FIRE SAFETY UPGRADE STRATEGY REPORT

220 Bentinck Street, BATHURST NSW 2795

Client:	St Stanislaus College
Reference:	23175
Revision:	02
Date:	11/08/2023

Davis Group has been engaged by St Stanislaus College to prepare a Fire Safety Strategy Upgrade Report for the purposes of Section 64 of the Environmental Planning and Assessment Regulation 2021.

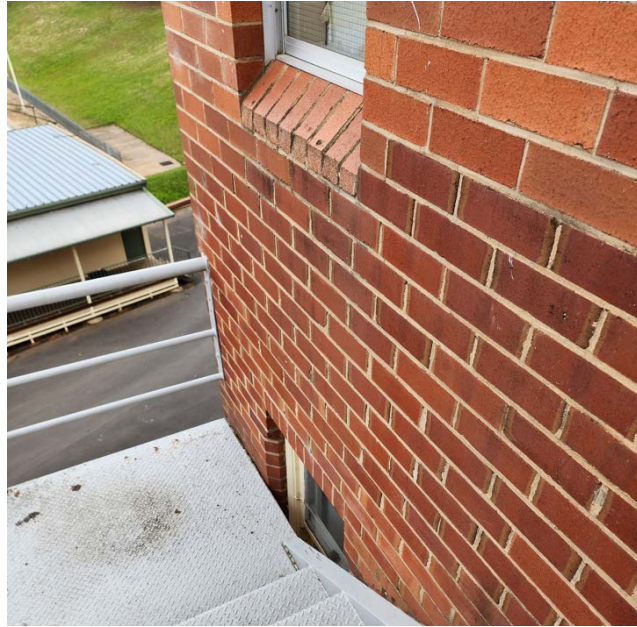
<u>Exposure - walls</u> The stairway is located within 6 m of, and exposed to, parts of the external walls of the building it serves. The external walls are of masonry construction and likely to achieve a FRL of at least 60/60/60. It is recommended no upgrade occur to the existing masonry external walls of the building that are located within 6 m of fire stair 6. <u>Exposure - roof</u> The corrugated roof and skylights are unlikely to achieve a FRL of at least 60/60/60, which is contrary to D2D13(3).  It is recommended the existing roof and skylights be upgraded to comply with the Performance Requirements of the BCA via a Performance Solution prepared by a Certifier – Fire Safety. This is likely to rely upon the proposed sprinkler system.	No Upgrade Performance Solution
--	--	---	---

It is recommended the openings located more than 3 m, but less than 6 m from the stairway and pathway be fixed shut and protected with internal wall-wetting sprinklers to comply with D2D13(3).

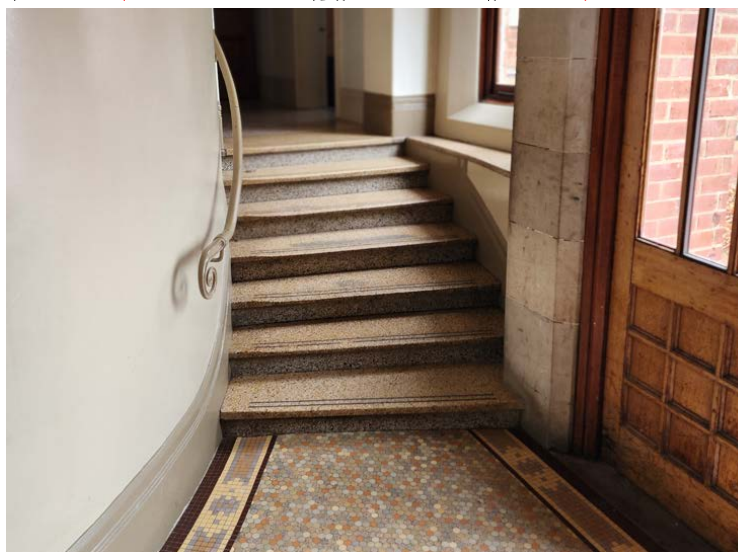
Two flights of stairs in fire stair 9, that are located on the Ground Storey, are provided with curved treads that result in the flight having inconsistent going dimensions, which is contrary to NSW D3D14 and Table D3D14.

Block A – Ground Storey – Kitchen Servery

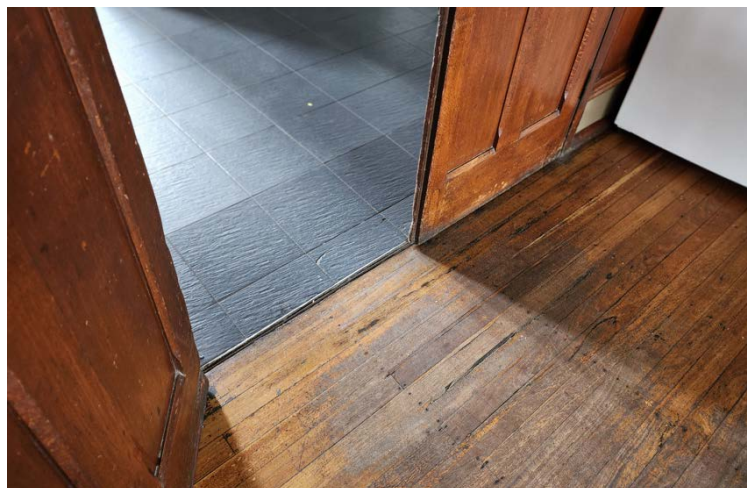
The internal door located between the kitchen servery and boarder's refectory contains a minor threshold ramp due to the different floor materials.

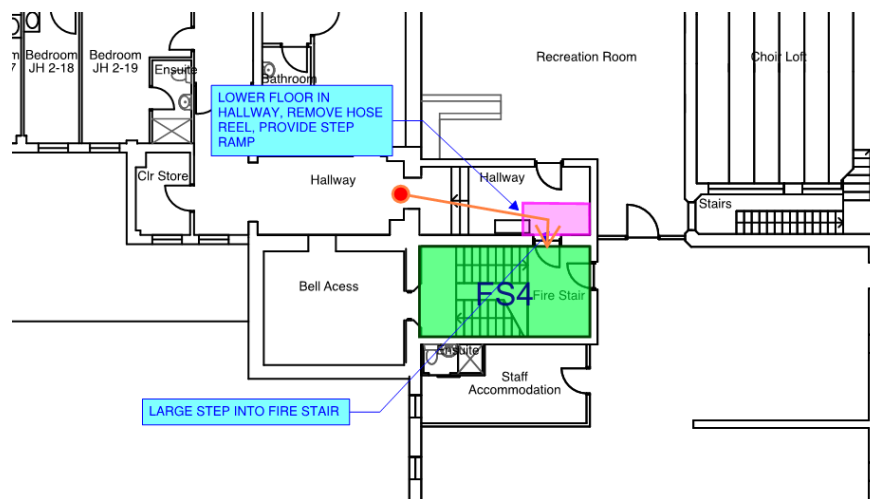
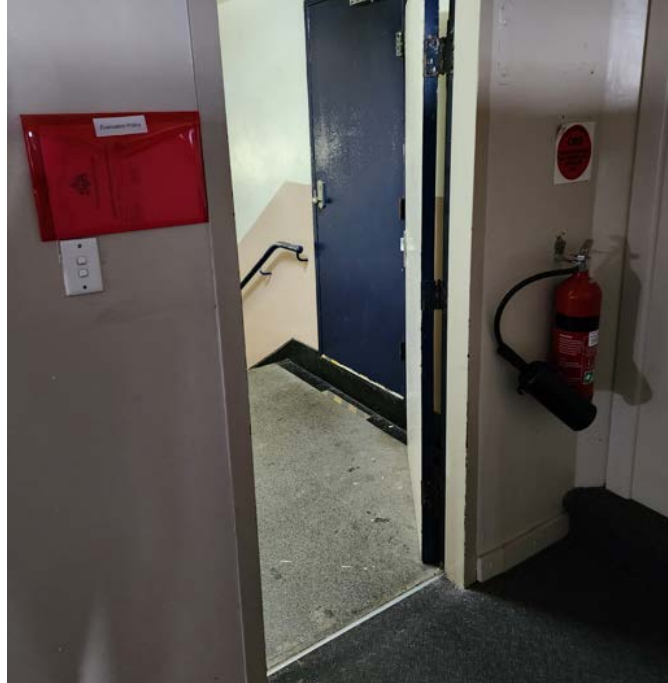
The doorway leading into fire stair 4 on the Second Storey contains a step inside the fire-isolated shaft, which is contrary to NSW D3D16.

It is recommended the finished floor level in the hallway (approximately marked up in purple on the plan above) be lowered by approximately 190 mm to align with the finished floor level inside fire stair 4.

Block A – Fire Stair 6

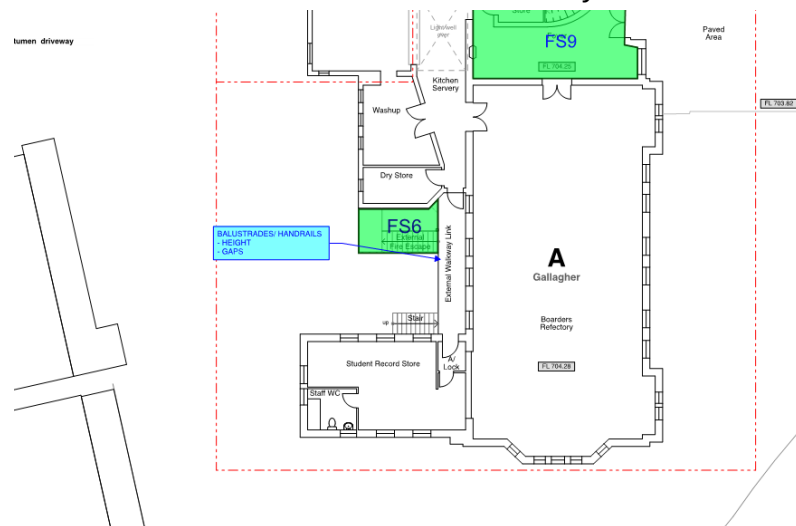
The heights of the balustrades to prevent falls located adjacent to fire stair 6 are less than 1 m, which is contrary to NSW D3D18.

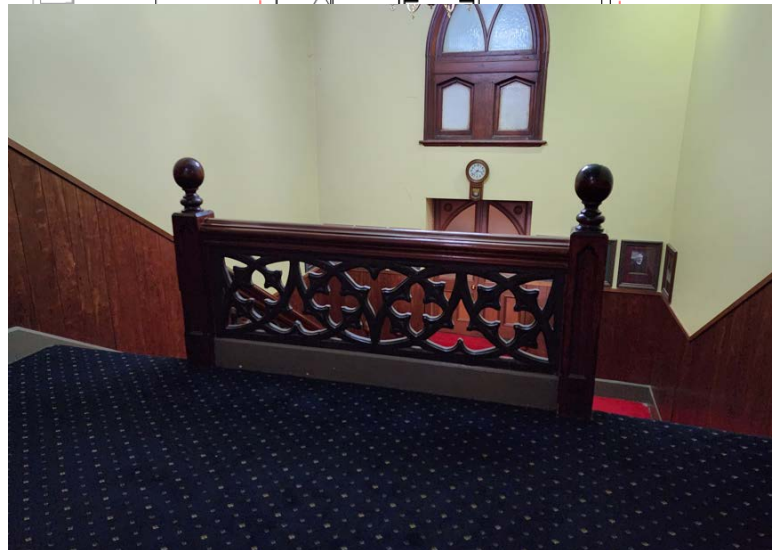
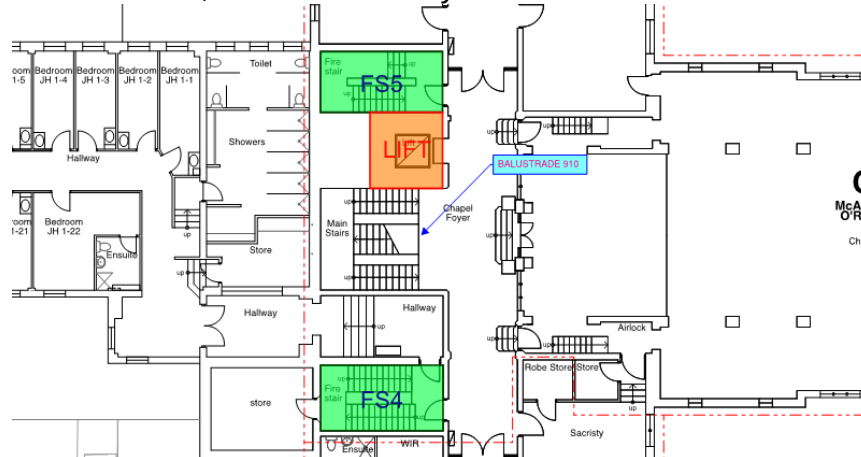
The main stairway has an ornate heritage timber barrier to prevent falls on the First Storey. The height of the barrier is approximately 910 mm and the trafficable surface is more than 1 m above the surface beneath, which is contrary to NSW D3D18.

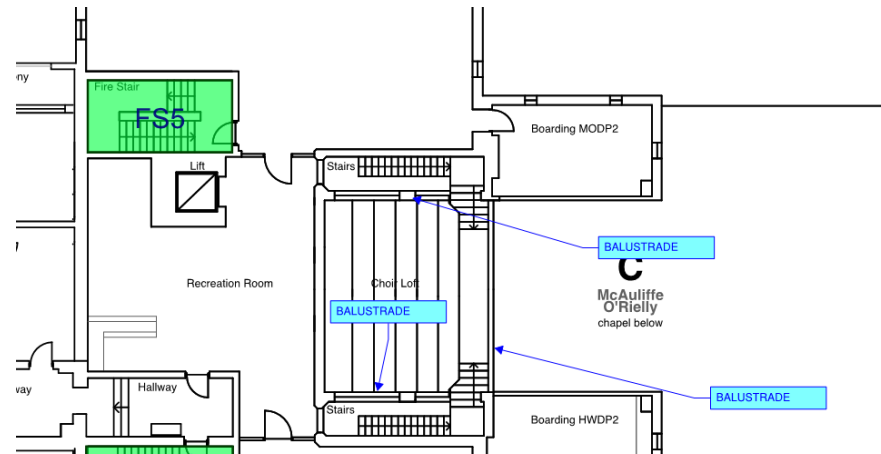
The barriers to prevent falls located on the front and sides of the choir loft have a height of less than 1 m.

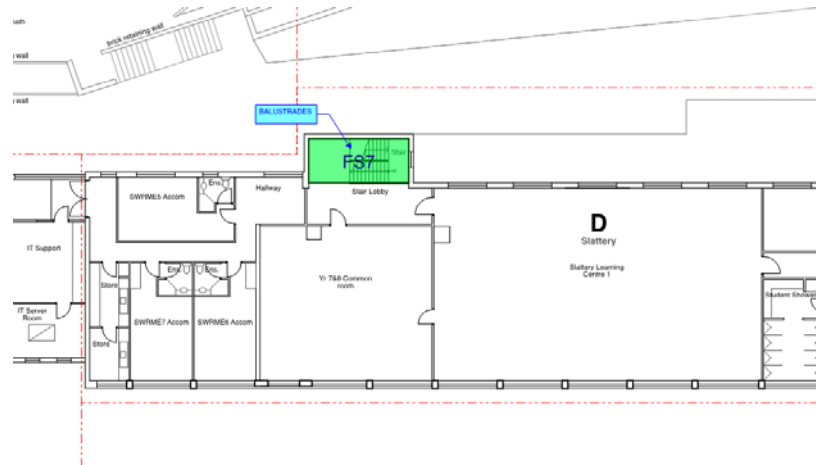
The barriers to prevent falls located on and adjacent to the top of fire stair 7 have a height of approximately 840 mm, which is less than 1 m.

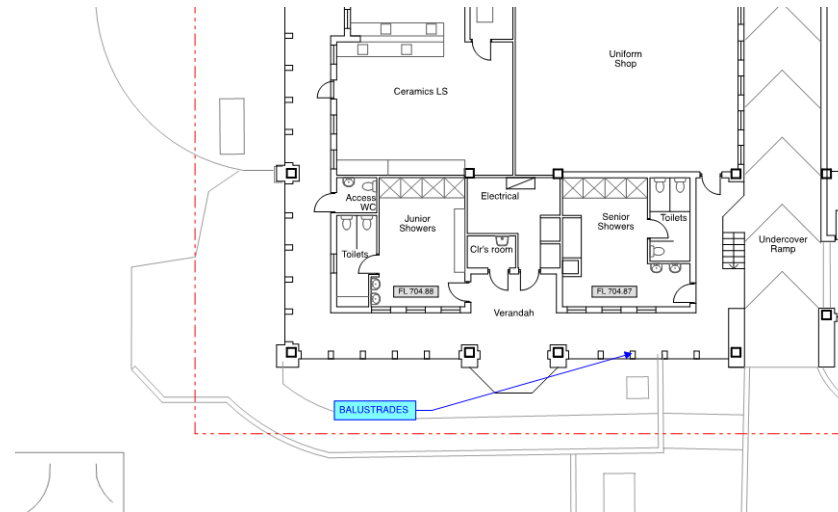
The external verandah located on the Ground Storey of Block F has a trafficable surface that is more than 1 m above the surface beneath and has a balustrade that has a height of less than 1 m.

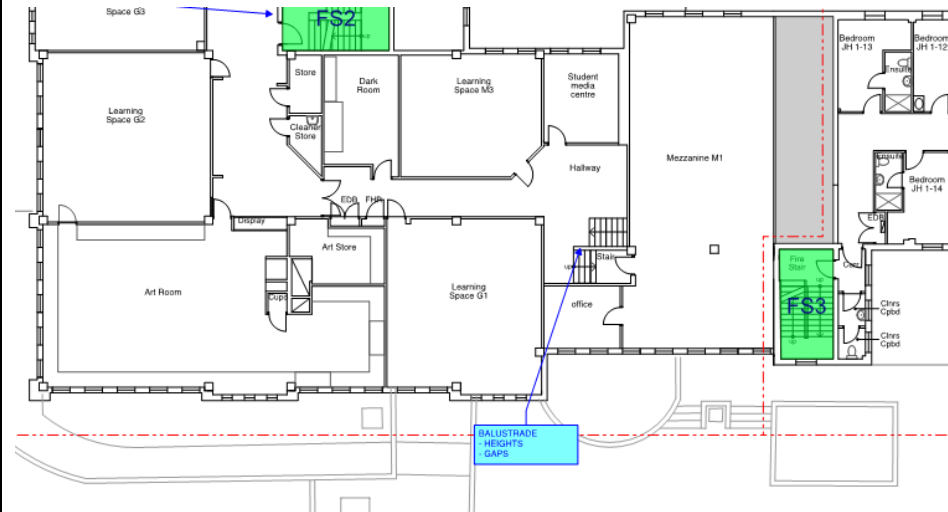
The barrier located adjacent to the internal stair located on the First Storey of Block F has a height of less than 1 m.

Block F – Outdoor Patio

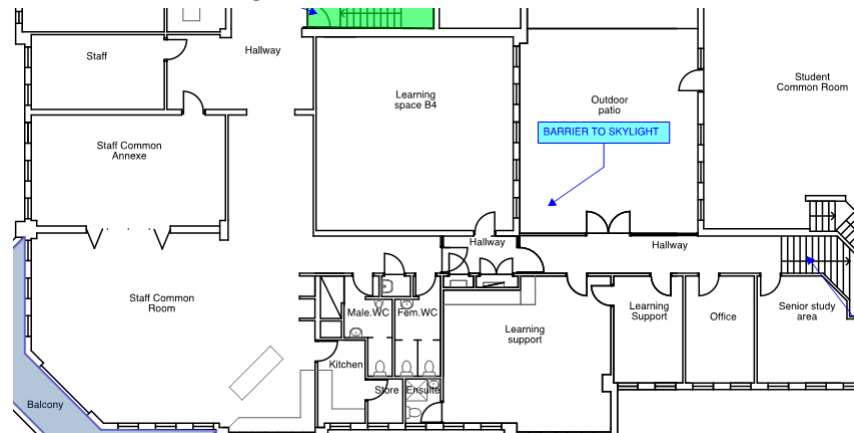
The barrier located adjacent to the skylight located in the outdoor patio area has a height of less than 1 m.

Block A – Fire Stair 6

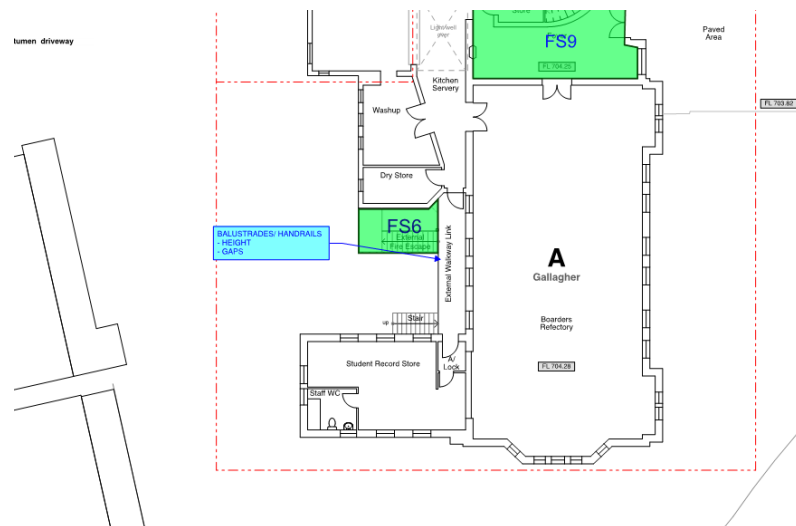
The barriers to prevent falls located adjacent to fire stair 6 contain gaps in excess of 125 mm.

Block C – Second Storey – Choir Loft

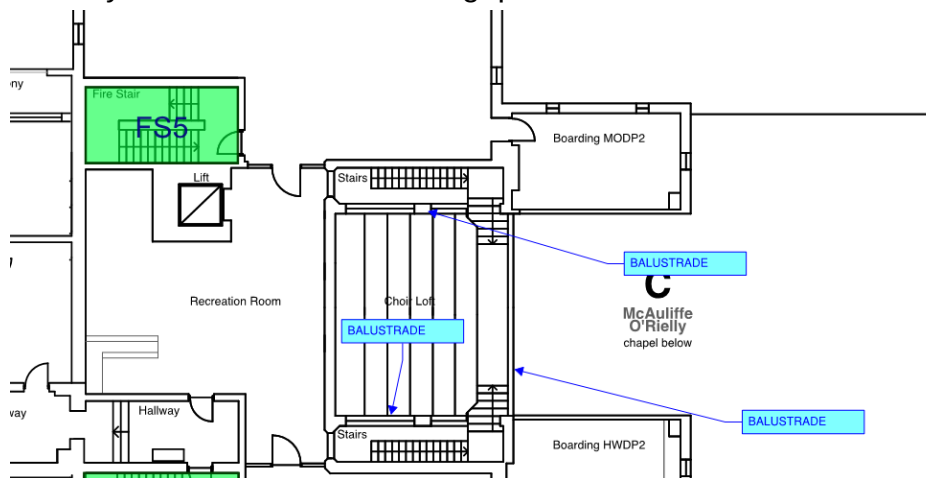
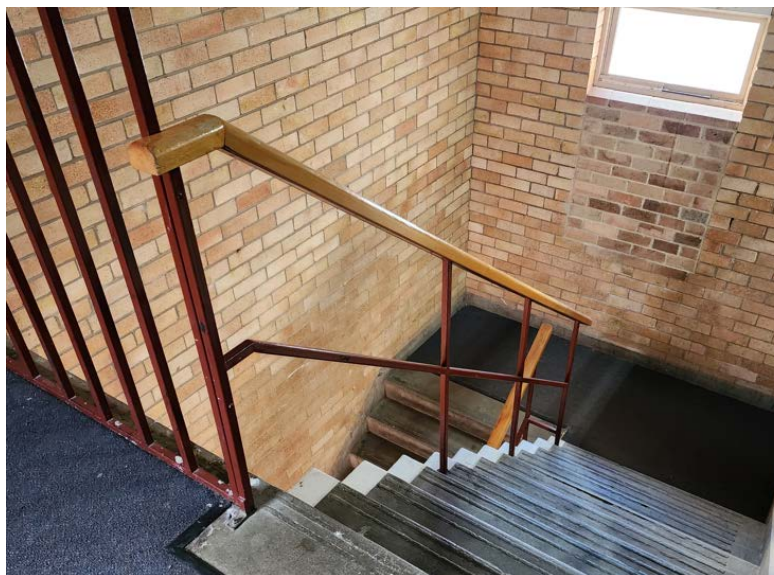
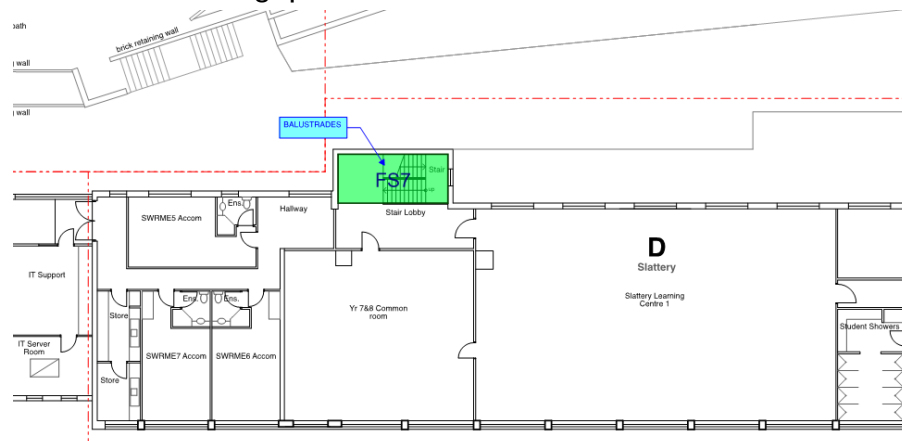
The barriers to prevent falls located along the front, side and stairway of the choir loft contain gaps in excess of 125 mm.

It is recommended the existing barriers to altered and upgraded to comply with D3D19.

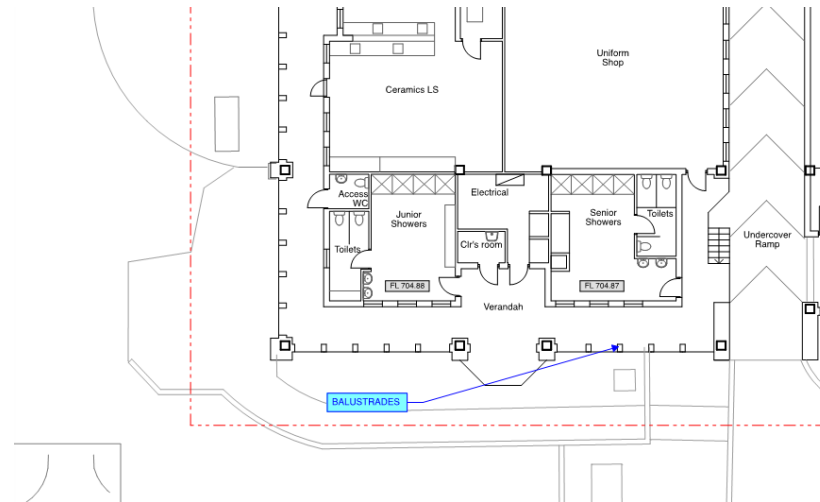
The external verandah and stair located on the Ground Storey of Block F has a trafficable surface that is more than 1 m above the surface beneath with gaps more than 125 mm.

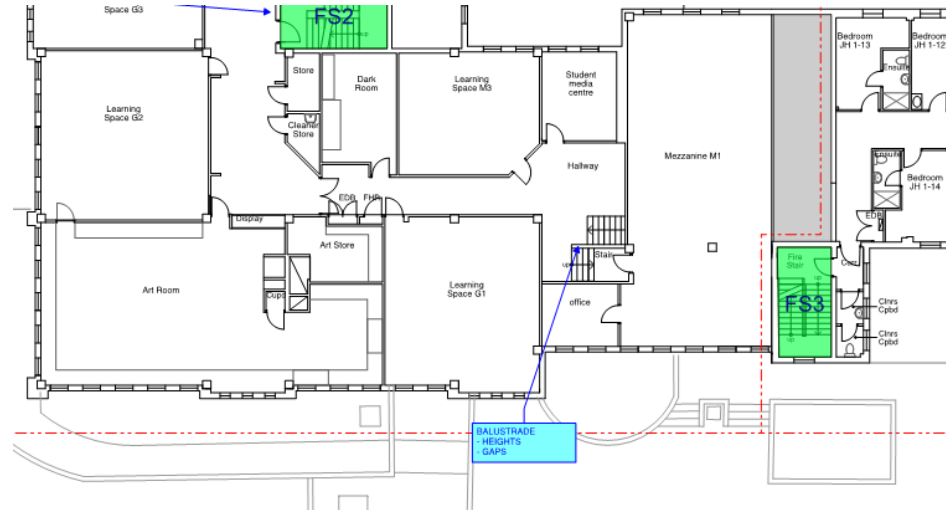
The barrier located adjacent to the internal stair located on the First Storey of Block F contains gaps in excess of 125 mm.

Block F - Fire Stair 1 and 2

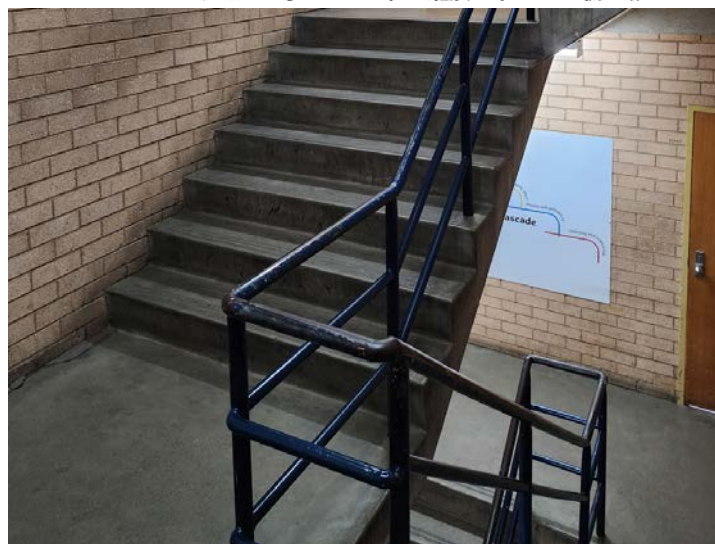
Fire stairs 1 and 2 are not required to be fire-isolated. The barriers to prevent falls contain gaps that exceed 125 mm.

Block F – Outdoor Patio

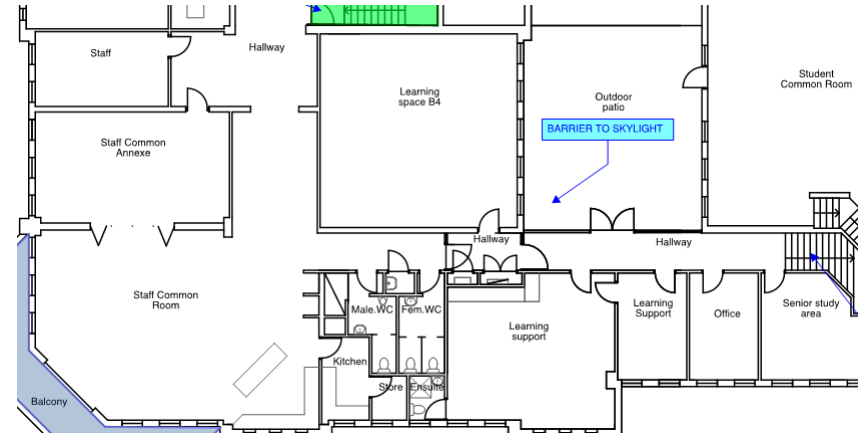
The barrier located adjacent to the skylight on the outdoor patio area contains gaps in excess of 125 mm.

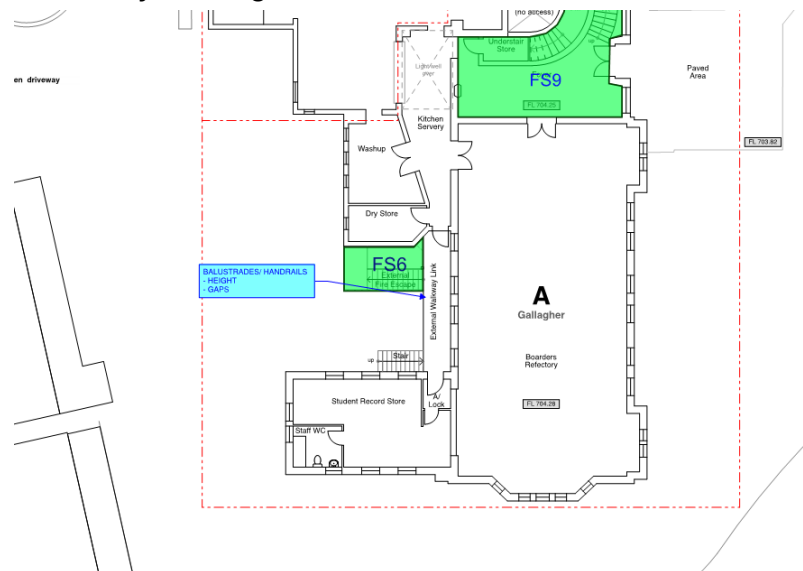
The handrail adjacent to fire stair 6 is provided with a handrail that requires an occupant to break their grip at the landing at the Ground Storey landing.

Block E – Ground Storey

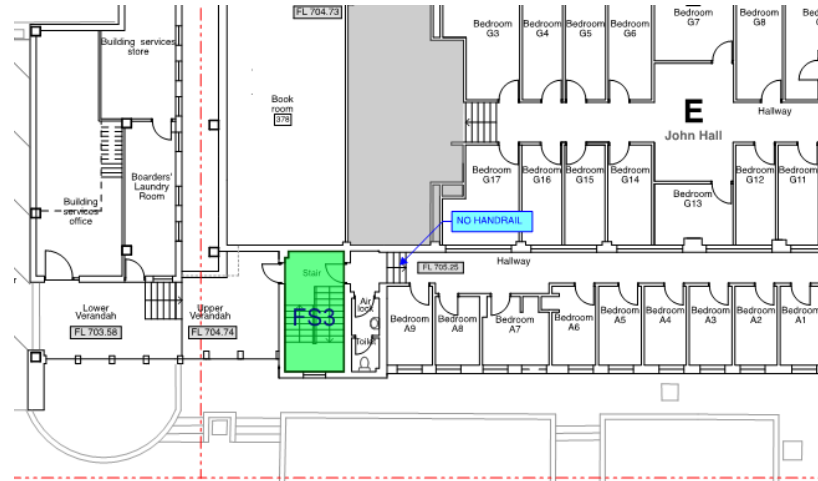
The internal stairway located near fire stair 3 on the Ground Storey of Block F is not provided with a handrail.
